### **SH16 Brigham Creek to Kumeu Stage 2 - Notice of Requirement Section 92 Response**

The following sets out our response to Auckland Council's RMA Section 92 request (dated 23/01/2023), in relation to the Notice of Requirement to Alter Designations 6740 and 6766 for State Highway 16 (Stage 2) Brigham Creek to Kumeu Safety, Capacity and Walking and Cycling Improvements, on behalf of Waka Kotahi New Zealand Transport Agency ("Waka Kotahi").

**Figure 14: Suggested safety improvements at crossing**

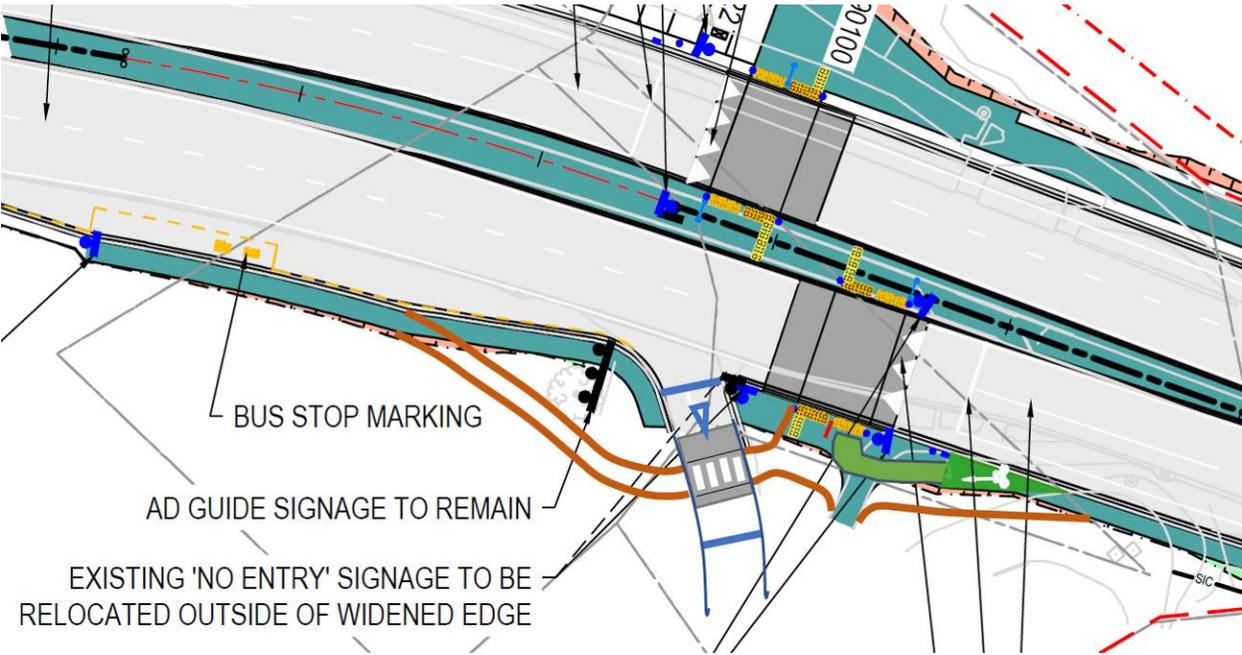
Suggested safety improvements are shown in Figure 14.

**Figure 15: Suggested footpath extension at The Grind café at Kennedys Road**

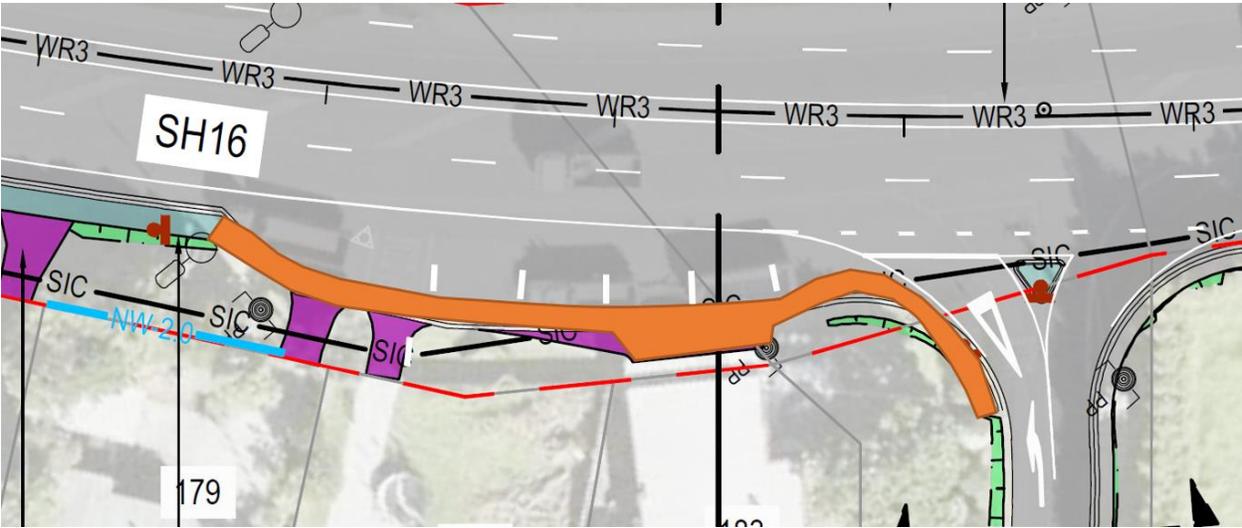
A suggested footpath is shown in orange in Figure 15.

**Figure 16: Suggested cyclist and bus passenger conflict separation at bus stop**

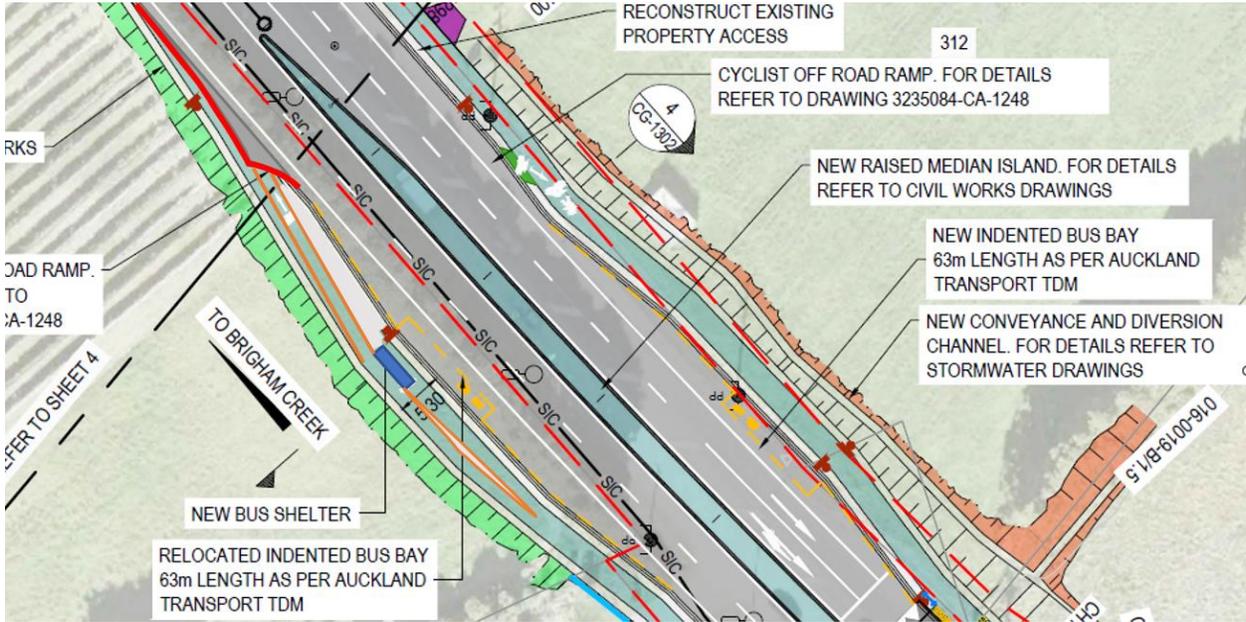
The eastbound cycle bypass is shown passing through the bus stop with no demarcated or positive conflict separation between bus passengers and cyclists, although the typical cross-section on Drawing CG-1302 does show the cycle path passing behind the bus shelter.

A suggested improvement in conflict separation is shown in Figure 16.

- 1 Adopt the suggested layout in Figure 16, to reduce the conflict between cyclists and bus passengers alighting the bus.

**Figure 17: Suggested safety improvements to Coatesville-Riverhead crossing and accesses**

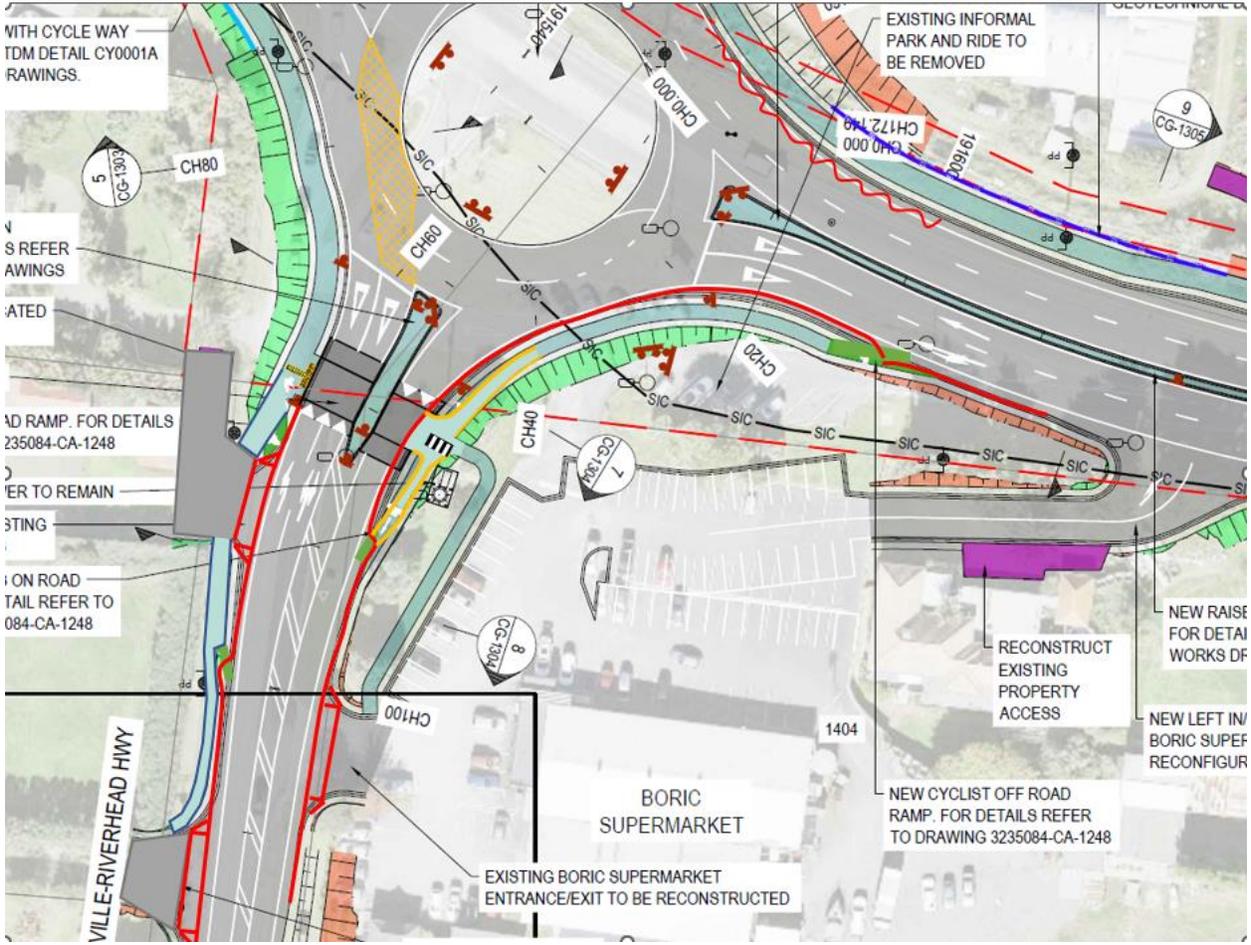
One-way cycle bypass paths need be only 1.5 m wide, which will provide some extra space for the suggested safety improvements shown in Figure 17 to be implemented. The shoulder around the perimeter of the roundabout must be omitted and must not be marked with a white line. The red lines in Figure 17 indicate the suggested kerb line coinciding with the white edge lines shown on the drawings. The yellow lines indicate the realigned cycle bypass to provide larger radius manoeuvring turns for cyclists.

As recommended in Section 2.1.1, the accesses to Boric supermarket, the nursery, and No 1411 are shown as commercial kerb crossings. This has the advantage of providing a larger combined shared access for the nursery and No 1411, which should ease turning movements.

- 1 Amend the layout as suggested in Figure 17.
- 2 Add a 'no pedestrians' sign at the northern end of the one-way cycle bypass on the western side of the raised safety platform.

**Figure 18: Cycle bypass and danger area demarcation philosophy**

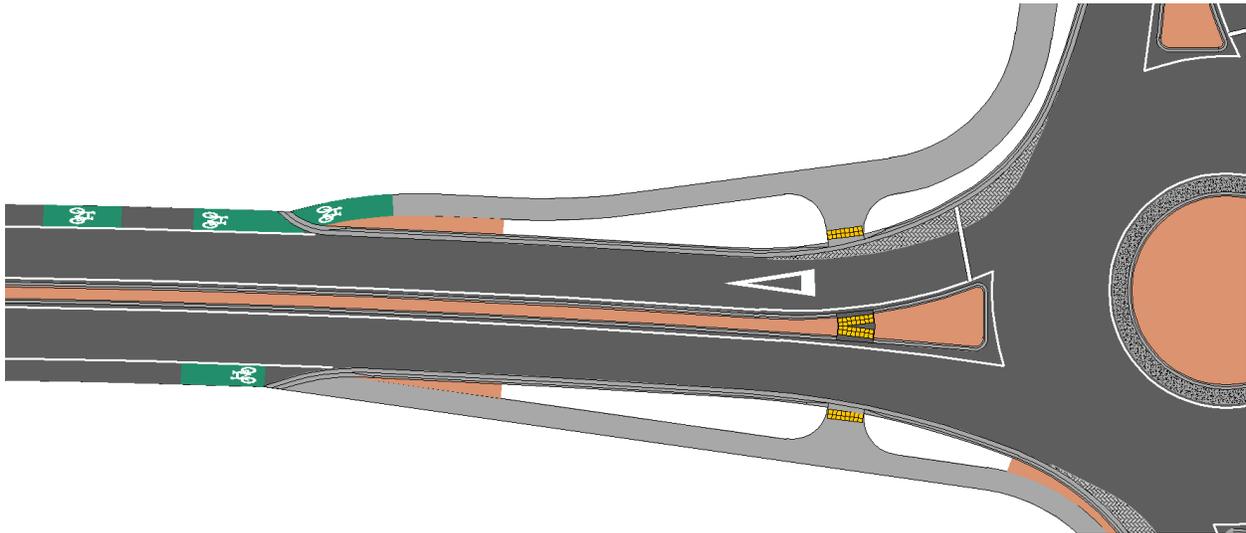
The Waka Kotahi Cycling Network Guidance Group has endorsed the following improvement to the markings where a cycle bypass has been provided. The philosophy is to indicate the safest route for cyclist by means of a green panel leading from an abruptly terminating shoulder onto the path. Thereafter, no shoulder or edge lines are to be marked for left-turning traffic and the lane width reduces to a constant 3.5 m wide up to the limit line to indicate to those cyclists who wish to remain on the road that they should take ownership of the lane and not try to cycle next to a heavy or indeed any vehicle. The area required for trailer tracking in the vicinity of the limit line is marked with a flush textured treatment. It is on the same crossfall plane as the approach to the roundabout so that surface water flows to the kerb and channel. The surface should be one that is not comfortable but still safely traversable for cyclists. This is to encourage cyclists to continue to hold onto their ownership of the lane and not move to the kerb and into the danger area described above. Figure 18 illustrates the philosophy.

- 1 Do not carry the shoulder marking edge line through to the limit line.
- 2 End the shoulder abruptly at the ramp leading to the cycle bypass path.
- 3 Consider adopting the latest arrangement that demarcates the danger area for cyclists as described above and shown in Figure 18 with the approval of Waka Kotahi.

**Figure 20: Safety barriers between kerbs and edge of shared path**

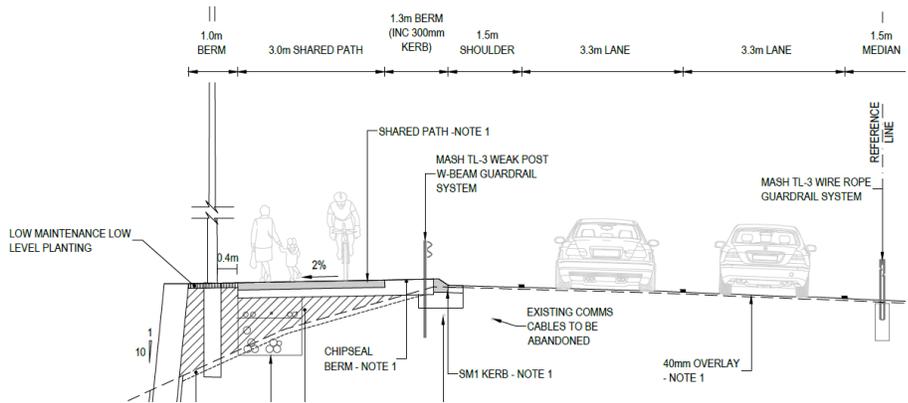
The drawings show semi-rigid barriers in the 1 m wide verge between the kerb and the edge of the shared path.

However, in the situation shown in Figure 20, a roughly 0.5 m wide verge to the footpath would be maintained and the risk described above would be reduced significantly.

**Figure 21: Safety barrier breaks at driveway crossings**

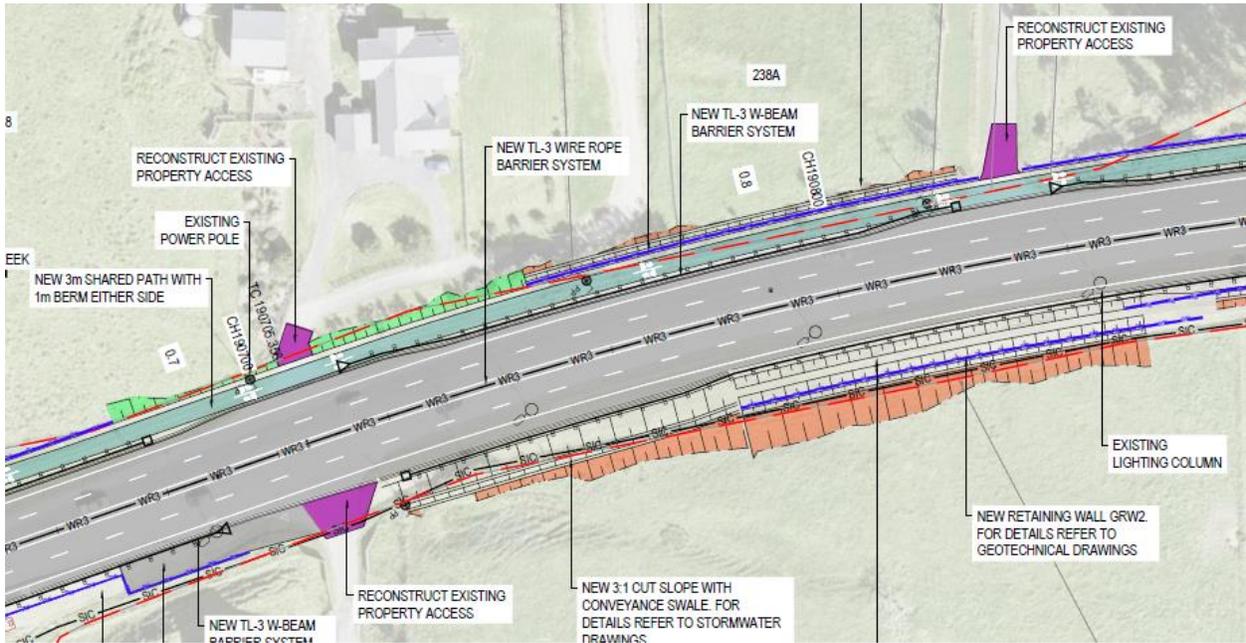
In the plan view in Figure 21, the alignment of the barrier kinks in and out at each driveway crossing, bringing the barrier and the roughly 300 mm wide sharp angular end terminals into the path and causing hazards to pedestrians and cyclists.
